# Wisconsin Department of Transportation

**Proposal #40: 8110-02-73**  
**Stillwater – Somerset**  
**Loop Trail System (Ped/Bike Facility)**  
**STH 64**  
**St. Croix County**

This is Addendum No. 02, which provides for the following:

**ADDENDUM NO. 02**

Addendum No. 02  
ID 8110-02-73  
Revised Sheet 129  
March 8, 2018

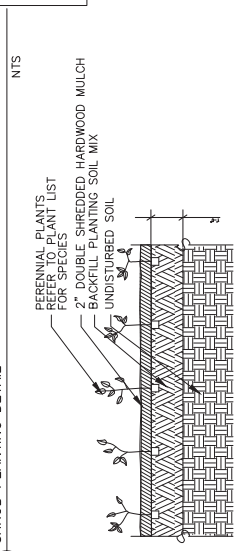
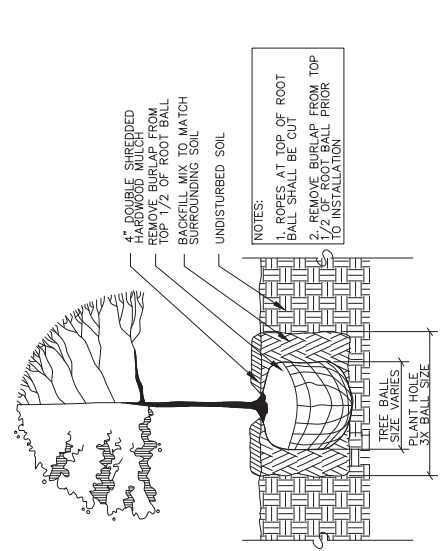
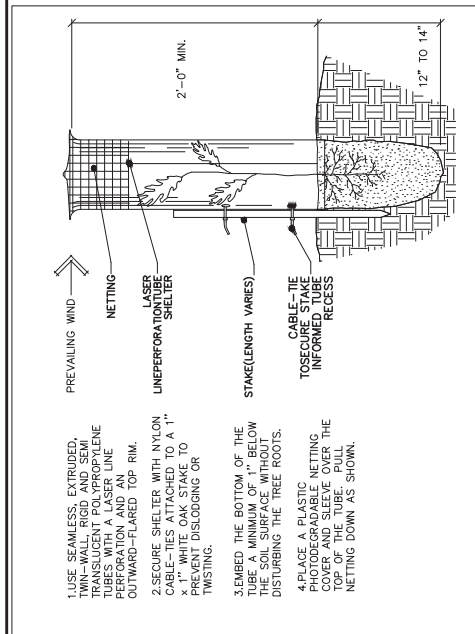
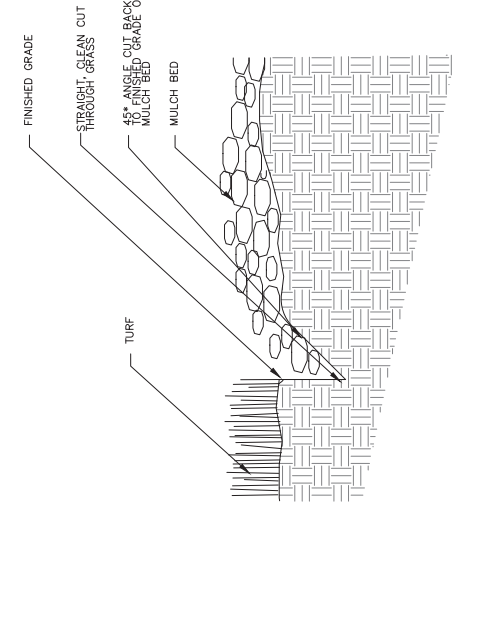
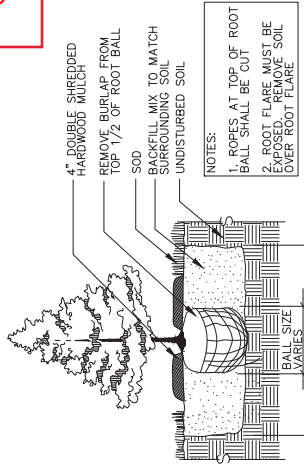
Revised Plan Sheets	
Plan Sheet	Plan Sheet Title (brief description of changes to sheet)
129	Landscape Details (Removed reference to weed free barrier around shrubs)
217	Miscellaneous Quantities (Updated Tree tables with reduced caliper sizes)
218	Miscellaneous Quantities (Updated Tree tables with reduced caliper sizes)
220	Miscellaneous Quantities (Revised Landscape Planting Surveillance and Care Cycles)
